STAFF REPORT 09-13-2023 MEETING

APPLICATION NUMBER: 23-8515

ADDRESS: 300 MADISON

SCOPE: ERECT BUILDING

Madison (top) and Randolph (bottom) Elevations, per submitted materials.

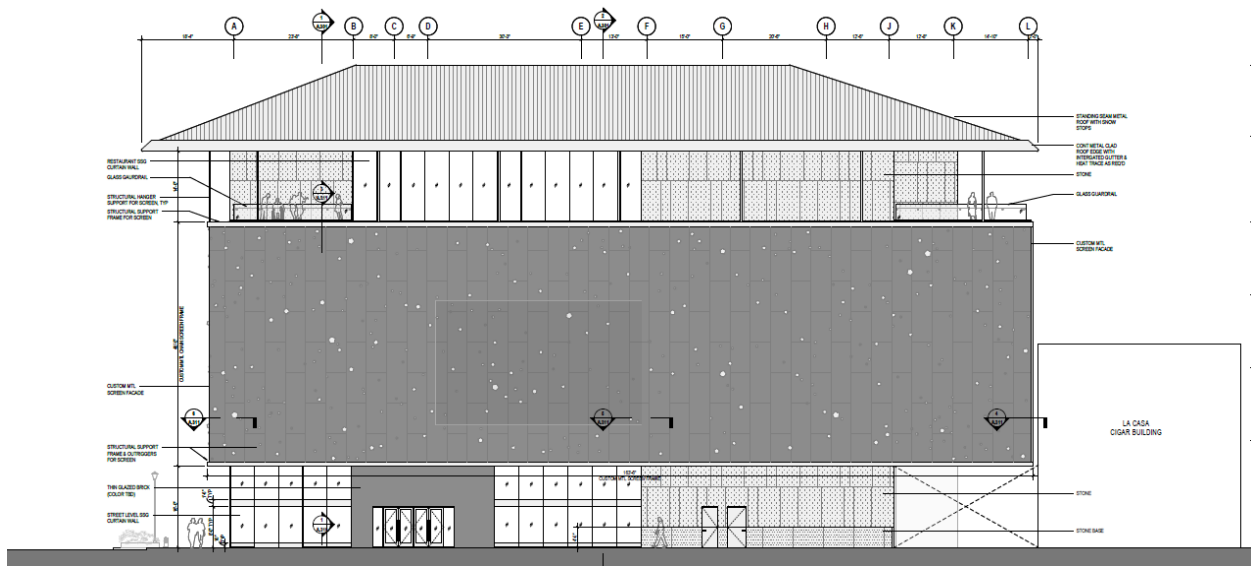
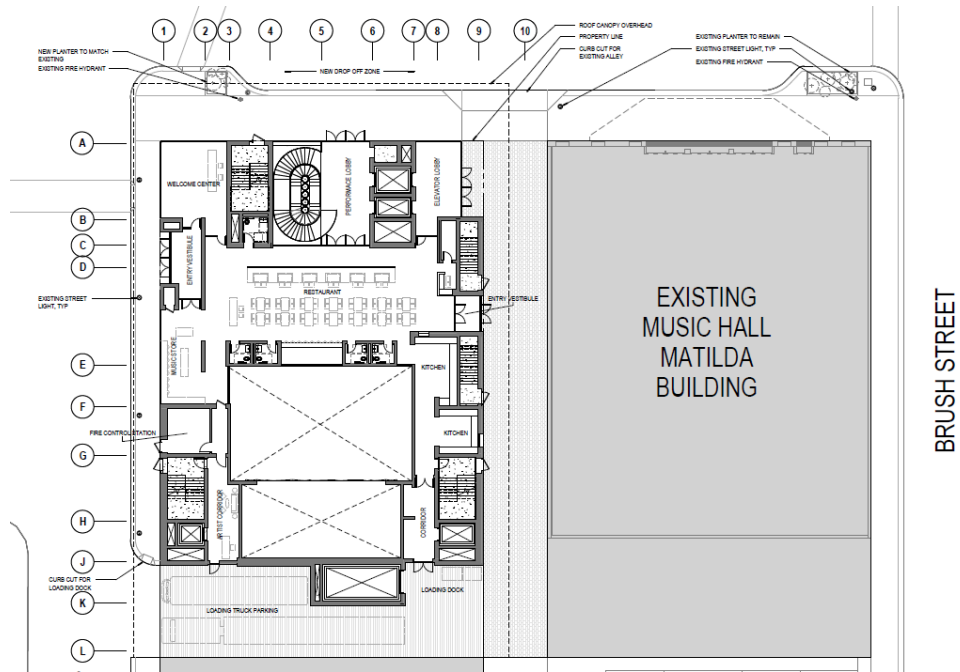
- **HDC Staff Assessment:** The proposal calls for a “pitched metal standing-seam roof” which cantilevers over corner and rear rooftop terraces. The cantilevered roof over top level terraces is a common expression in contemporary design. The pitched roof above the cantilever appears very prominent in the elevation drawings, though the perspective rendering provided appears to minimize its visibility (staff is doubtful that the roof has been rendered as depicted in the elevations). Nevertheless, the pitched roof is certain to be seen from more distant vantage points. The tiled, sloped front roof of 1502 Randolph mentioned in this Element is directly adjacent to the building (see photo on earlier page). Due to the height and bulk of the building, the pitched roof may not be particularly visible from the street nearby. However, the design may be stronger if the pitched roof is minimized, redesigned, or eliminated. Staff assesses that this Element has not been met.

- However, staff does recommend that the pitching and extent of the standing-seam metal roof above the cantilever be reconsidered to the extent feasible.

Preliminary Material Palette for Screen & Ornamental Jewel Attachments

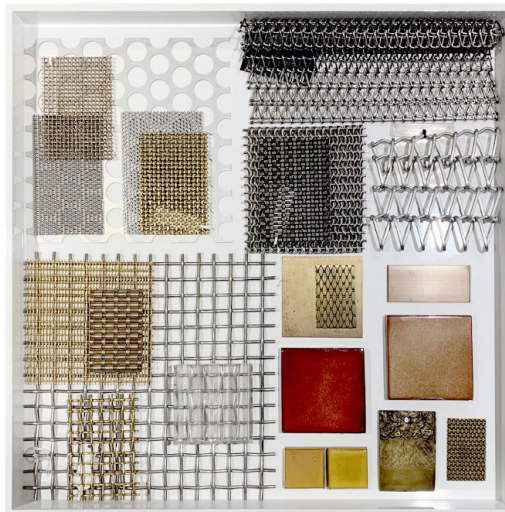
textures but are generally smooth. Substantial texture will be offered by the bespoke aluminum brise soleil at the 2nd through 4th floors at Madison and Randolph. Though undetermined, the color, form, and character of this screen is intended to symbolize the rich and vibrant musical history of Detroit. Staff believes that it is important that the texture created by the ultimate “form and character” of this screen be robust and pronounced, juxtaposing with the smoother areas of the building.

- A final issue is the ultimate treatment of the brise soleil screen, which is represented as a place-holder in the drawings/renderings. Because the design of this substantial element is currently undetermined, a wide range of textural and expressive outcomes may be possible. Staff recommends that the Commission may ask for this element of the building to be returned for final approval when a design is commissioned and developed. Alternately, with certain conditions or parameters discussed with the architect during this evening’s review, and established by the Commission, staff can be given authority to approve the final design.
